Bradley Farms: Preliminary Plan No. 120170010

Staff Report Date: 2/17/17

Request to resubdivide Lot 11, Block 8 on Record Plat 24443 (9005 River Road) to create two lots for two single-family detached dwellings; 6.33 acres; RE-2 zone; Located at the southeast corner of Durham Drive and River Road (MD 190), approximately 2,000 feet northwest of Bradley Boulevard (MD 191) in Potomac, MD; 2002 Potomac Subregion Master Plan.

Figure 3 - Proposed Preliminary Plan

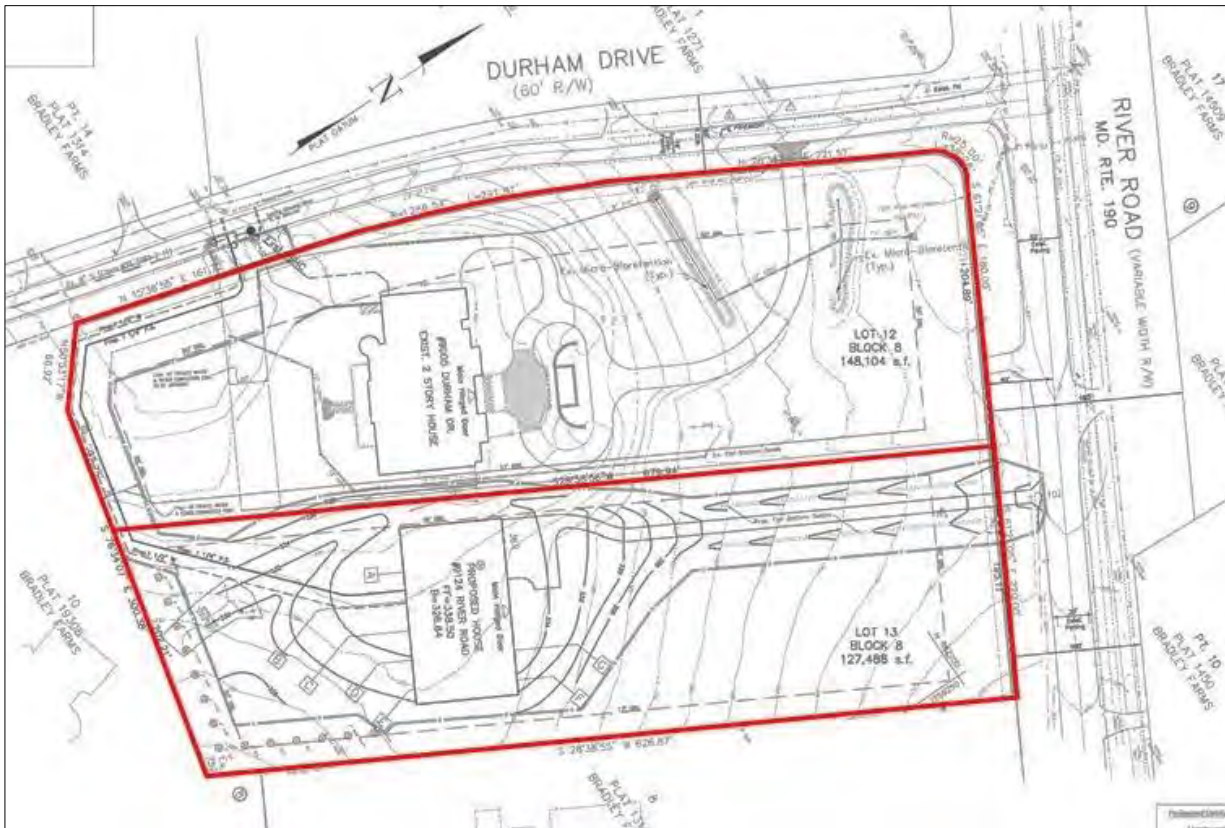
*Durham Drive* - Durham Drive is not a master planned road and is classified as a Secondary Residential Street with a 60-foot wide right-of-way per MCDOT. The Applicant has agreed to enter into a covenant with MCDOT for future improvements to Durham Drive which was included in their initial recommendation letter, dated December 11, 2011 (Attachment B), and is included in their revised letter dated November 1, 2016 (Attachment C).

As stated in their revised letter, the Property's southernmost access point was not properly permitted and does not meet sight distance requirements for a secondary road. Therefore, this driveway will be eliminated at the request of MCDOT. The northernmost driveway on Durham Drive closest to MD 190 will continue to provide vehicular access to the existing house on Lot 12. No additional dedication is required on Durham Drive.

*River Road (MD190)* - The Application has been reviewed by the MDSHA which determined that a district office permit will be required for the proposed residential driveway to River Road to serve proposed Lot 13. A second, unused driveway apron on MD 190 will be removed.
